# Access Compliance Report

## Public Rights-of-Way

Intersection ID: 53147	Main Street: ACHIEVEMENT_LN	Cross Street: NEW_RENAISSANCE_WY	Location: SE
ADA ID: 0CCB202768E8	Ramp Type: Directional1	Initial Pass/Fail: Fail	Overall Compliance: No
Severity Score: 1.25			
Codes/Mitigation Info/Possible Solution		Field Measurements/Component Compliance

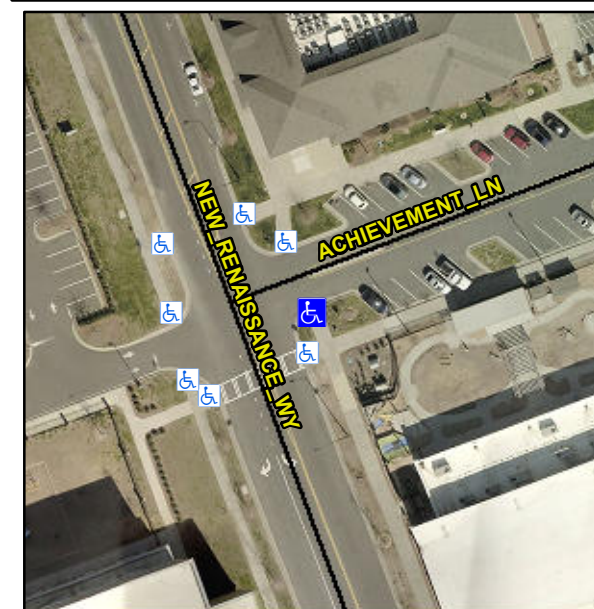
**R304.5.3**

Compliance	Description	Data	Compliance	Description	Data
N/A	Ramp Length (in)	77.0	N/A	Grade Break?	N/A
Yes	Ramp Width (in)	96.0	N/A	Grade Break Slope (%)	0.0
Yes	Ramp Slope (%)	7.0	N/A	Grade Break XSlope (%)	0.0
No	Ramp XSlope (%)	3.0			
N/A	Flare Type LT	N/A	N/A	Flare Type RT	N/A
N/A	Flare Slope LT (%)	N/A	N/A	Flare Slope RT (%)	0.0
N/A	Flare Traversable LT?	N/A	N/A	Flare Traversable RT?	N/A
N/A	Landing Length (in)	0.0	N/A	DWS Provided?	N/A
N/A	Landing Width (in)	0.0	N/A	DWS Contrast?	N/A
N/A	Landing Slope (%)	0.0	N/A	DWS Length (in)	N/A
N/A	Landing X Slope (%)	0.0	N/A	DWS Full Width?	N/A
N/A	Landing Curb? (Y/N)	N/A	N/A	DWS Offset LT (in)	N/A
N/A	Shared Landing?	N/A	N/A	DWS Offset RT (in)	N/A
N/A	Gutter Ponding?	0.0	N/A	Gutter Slope (%)	N/A
N/A	Gutter Lip Ht (in)	0.0	N/A	Gutter X Slope (%)	N/A
N/A	Painted X Walk1?	No		Road Slope (%)	2.0
	X Walk 1 Direction	To NW		Road X Slope (%)	1.6
	X Walk 1 Width (in)	N/A		Clear Space?	N/A

**Remove & Replace Entire Ramp.**

\$ 1600.00
